Docket Nos. 50-237
 50-249
 50-254
 50-265

The Commission has issued the enclosed Amendment No. 59 to Provisional Operating License No. DPR-19 for Dresden Station Unit 2 and Amendment Nos. 52, 70, and 64 to Facility Operating License Nos. DPR-25, DPR-29, and DPR-30 for Dresden Station Unit 3 and Quad Cities Station Units 1 and 2, respectively. The amendments are in response to your letter of November 1, 1979.

The amendments will allow reactor power ascension to proceed along a modified power/flow line. This will facilitate adherence to procedures designed to reduce fuel pellet-clad interaction.

SAFETY EVALUATION BY THE OFFICE OF NUCLEAR REACTOR REGULATION

FIGURE 2.1-3 (SCHEMATIC)

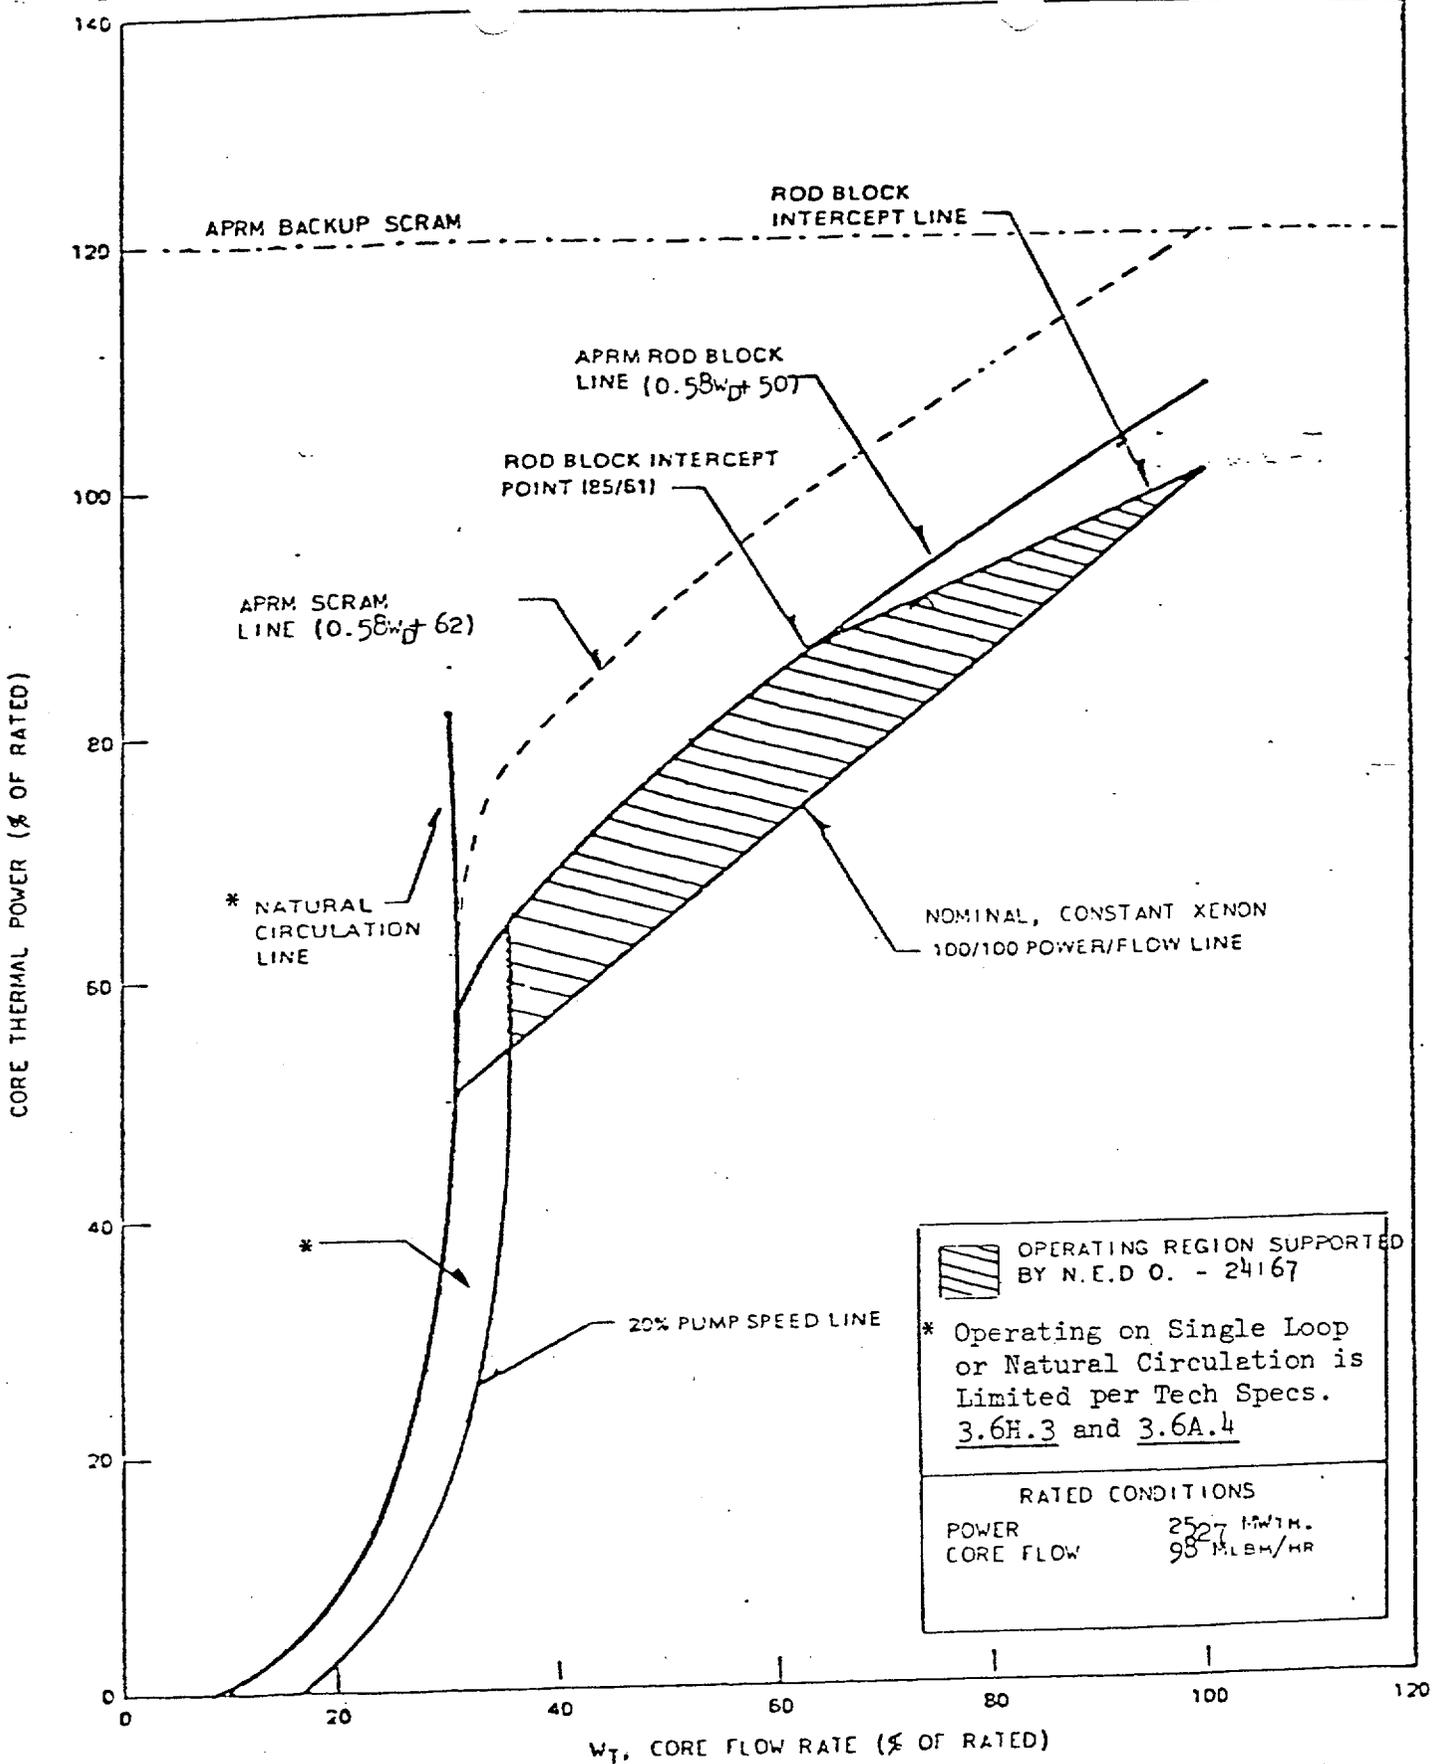
APRM FLOW BIAS SCRAM RELATIONSHIP TO NORMAL OPERATING CONDITIONS

$$S \leq [.58W_D + 50]$$

$$S \leq (.58W_D + 50) \left[\frac{FRP}{MFLPD} \right]$$

FIGURE 2.1-1

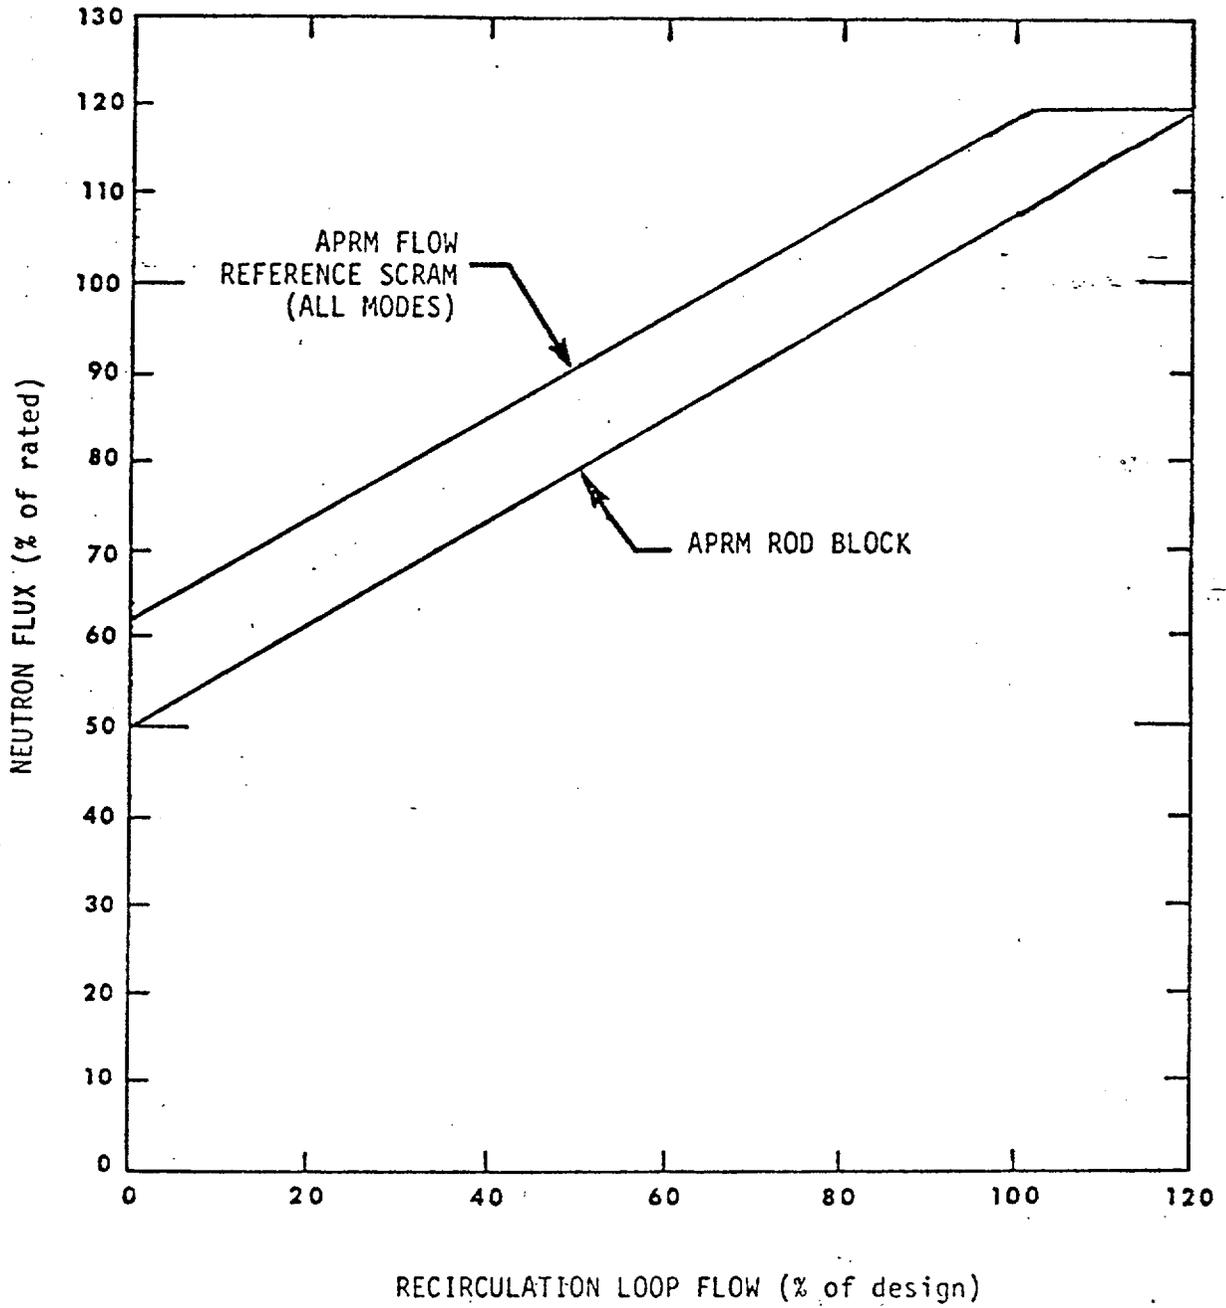
When the reactor mode switch is in the Run position, the APRM flux scram setting shall be as shown in Figure 2.1-1 and shall be:

The APRM rod block setting shall be as shown in Figure 2.1-1 and shall be:

$$S \leq (58W_D + 62)$$

$$S \leq (.58W_D + 50)$$

$$S \leq (.58W_D + 50) \frac{FRP}{MFLPD}$$

FIGURE 2.1-1

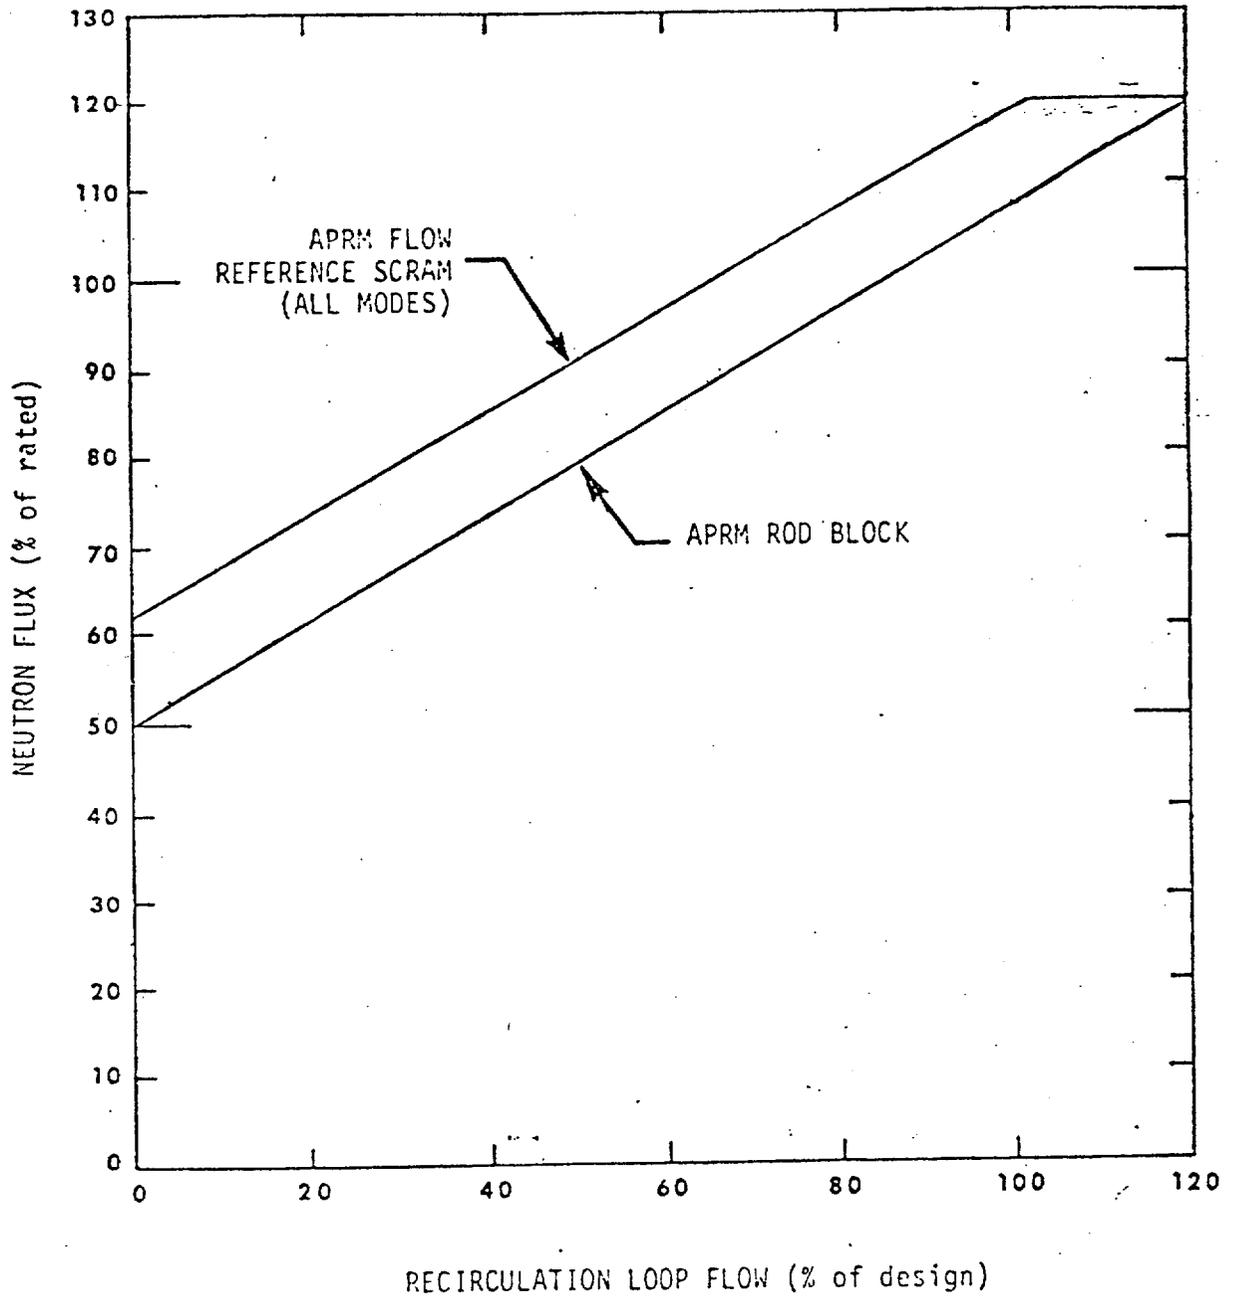
When the reactor mode switch is in the Run position, the APRM flux scram setting shall be as shown in Figure 2.1-1 and shall be:

The APRM rod block setting shall be as shown in Figure 2.1-1 and shall be:

$$S \leq (0.58W_D + 62)$$

$$S \leq (0.58W_D + 50)$$

$$S \leq (0.58W_D + 50) \frac{FRP}{MFLPD}$$
